## **Town of Arlington, MA Redevelopment Board**

### **Agenda & Meeting Notice September 27, 2021**

9:15 p.m. **Docket #3665, 645 Massachusetts Avenue**

645 Massachusetts Avenue  
Arlington, MA 02476

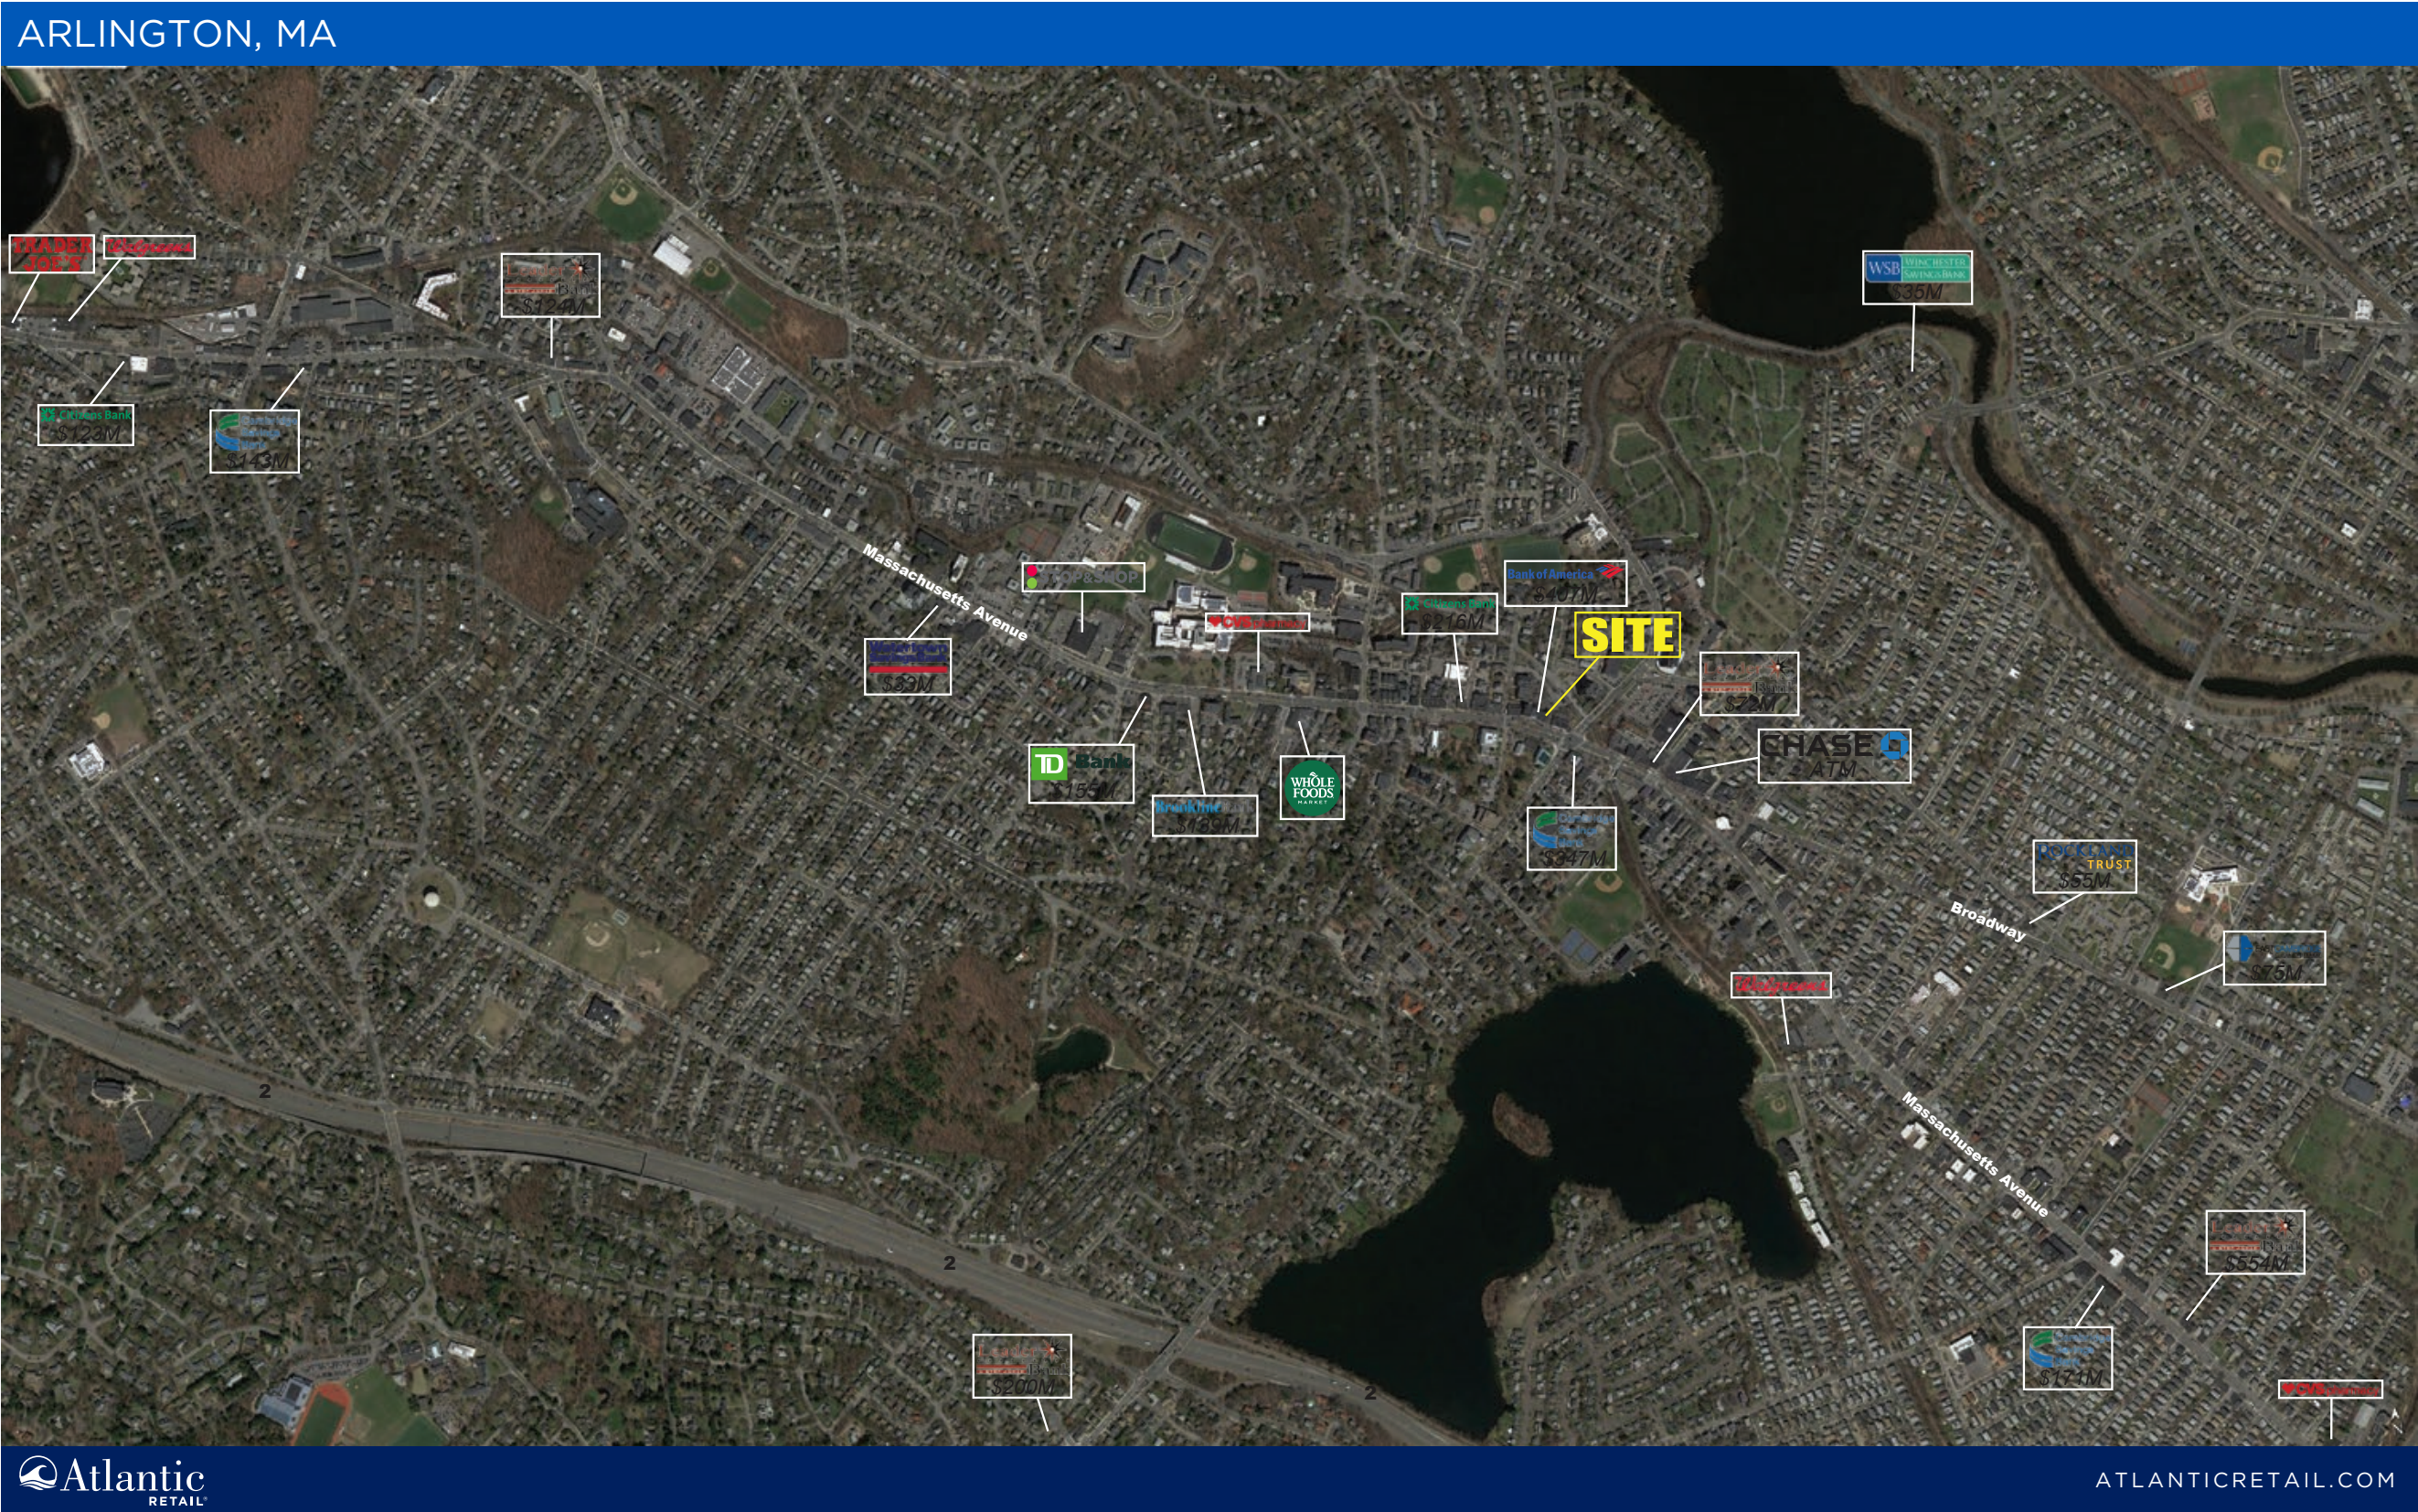
The Board requested that the Applicant install clear-glazed windows along the streetfront façade that align with the commercial district and use; move the proposed blade sign; maintain the existing sidewalk seating and planters from the prior tenant; address the rear access point for accessibility; and incorporate the required bike parking. The Board also asked the Applicant to provide a better description of their services and how they differ from similar business uses in Arlington Center.

Signage: The board was not in favor of the proposed blade sign. They believed the sign was not in keeping with other signage in the Central Business District as asked if we could consider moving the sign on the gray band along the alley side of the building. THE RENDERINGS HAVE BEEN REVISED TO INCORPORATE THIS CHANGE

06.23.21	JM	Delete Octagons from All Awnings. Add Option 2, E12 and E13
07.01.21	RJW	Revised as noted.
09.09.21	RJW	Delete E03, add lettersets & elevations.

East Elevation - David Lamson Way

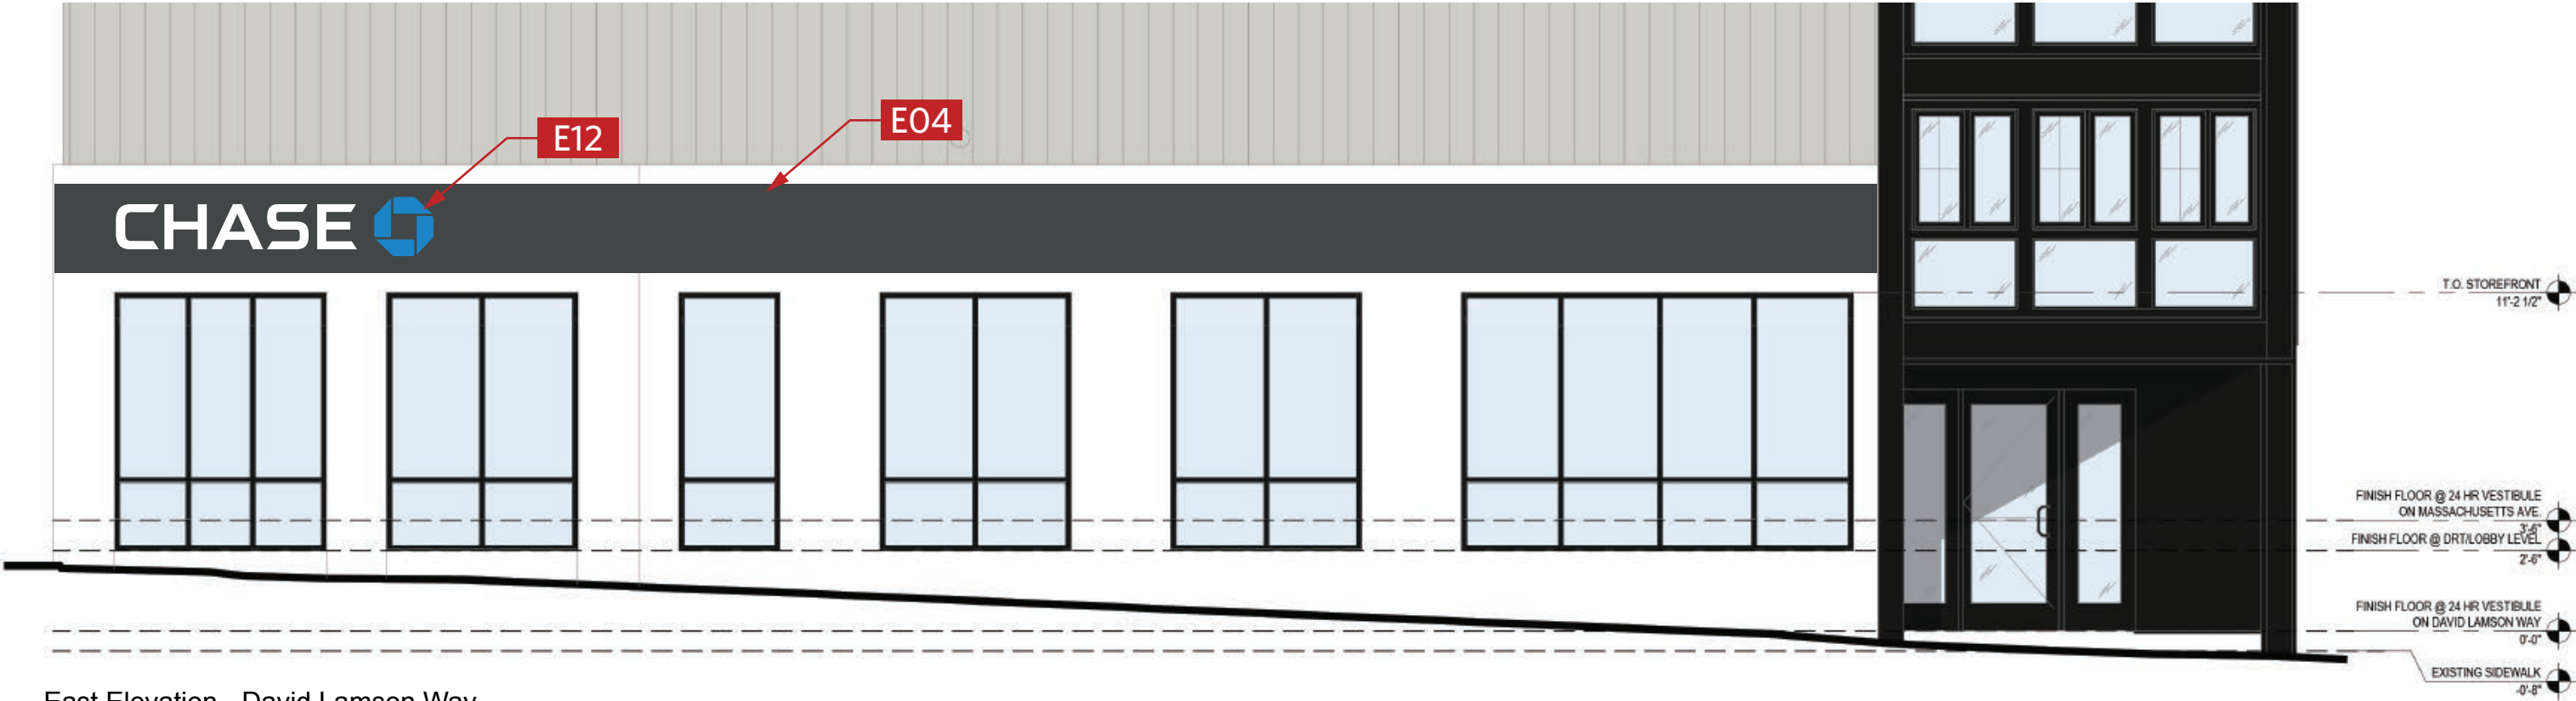
Regarding the windows along the Massachusetts Avenue and David Lamson Way facades, the renderings and elevations in the sign package show that the gridded windows will be replaced with commercial windows. It appears from the renderings that the glazing has also been addressed. Specifications on window type and glazing have not been provided.

Façade: The board recommended changing the existing gridded windows to match the proposed new windows. THE RENDERINGS HAVE BEEN REVISED TO INCORPORATE THIS CHANGE
